CITY OF ALBUQUERQUE

Re: Sandia Mechanical Office Warehouse
2731 Vassar PI NE
Traffic Circulation Layout
Architect's Stamp 04-15-24 (G16-D082B4)

TRAFFIC CIRCULATION LAYOUT

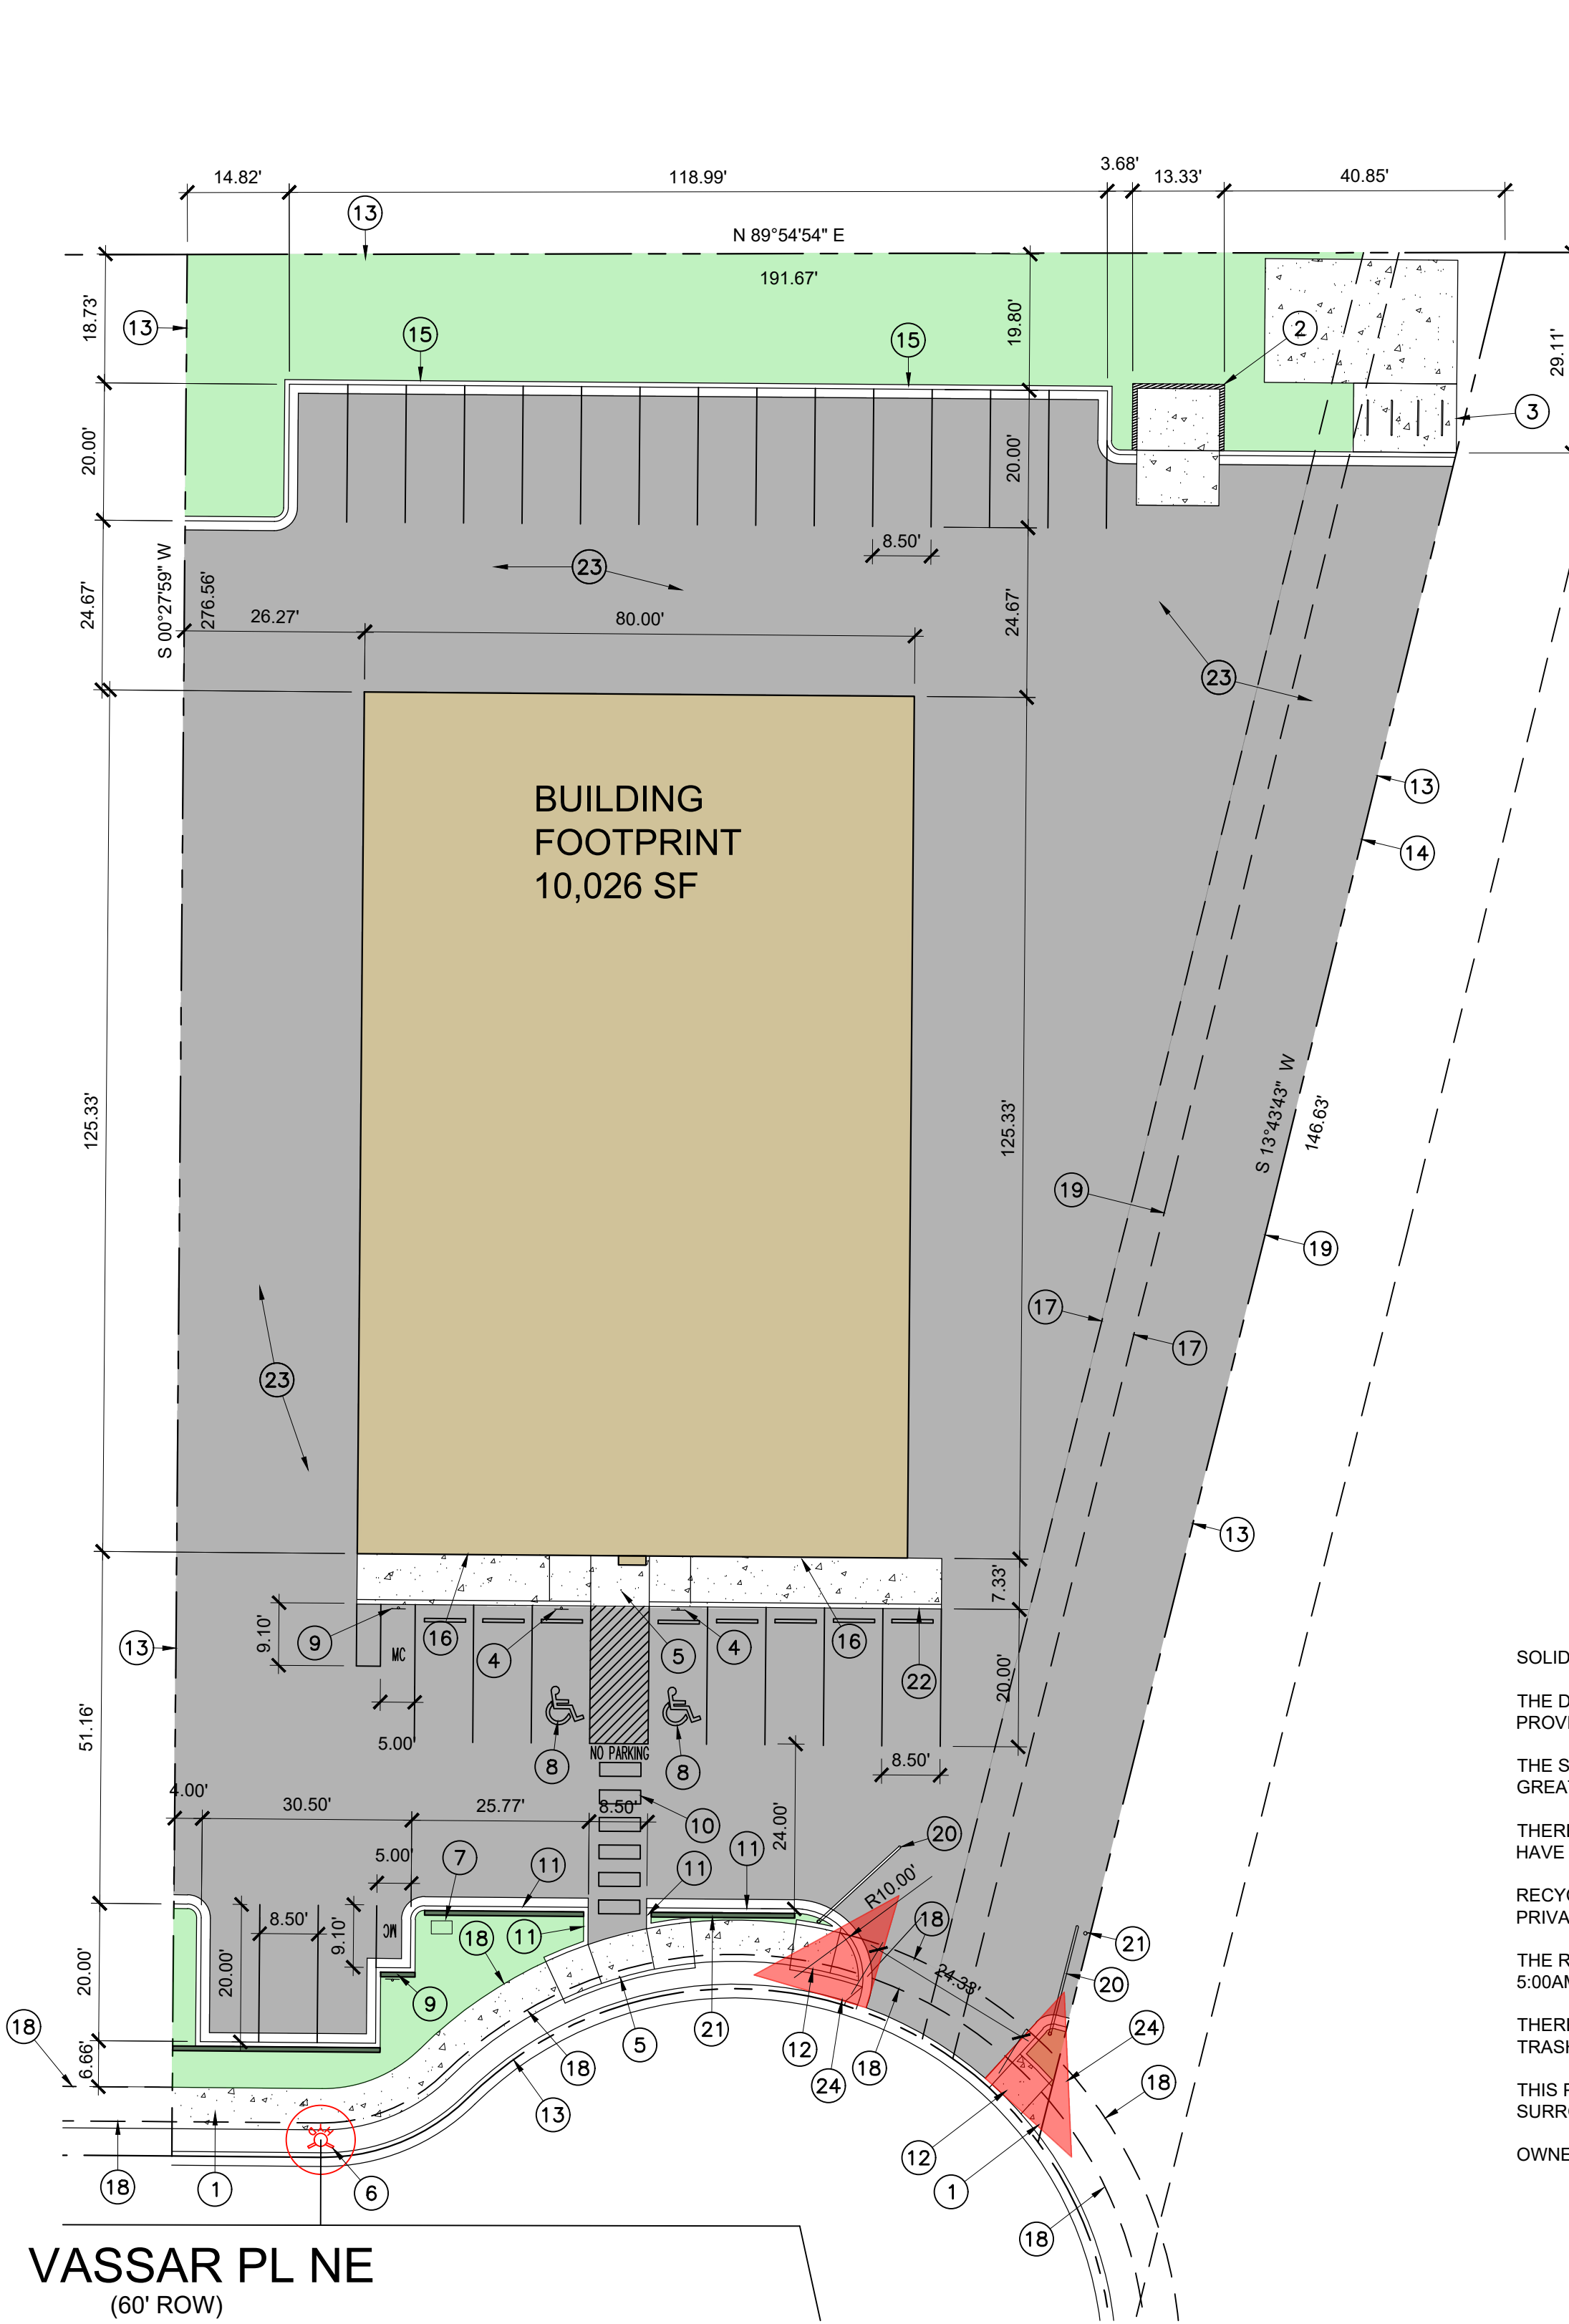
When the site construction is completed and an inspection for Certificate of Occupancy (C.O.) is requested, use the original City stamped approved TCL for certification. Redline any minor changes and adjustments that were made in the field. A NM registered architect or engineer must stamp, sign, and date the certification TCL along with indicating that the development was built in "substantial compliance" with the TCL. Submit this certification, the TCL, and a completed Drainage and Transportation Information Sheet to front counter personnel for log in and evaluation by Transportation. **Additionally, sidewalk easement is the condition for releasing the final CO.**
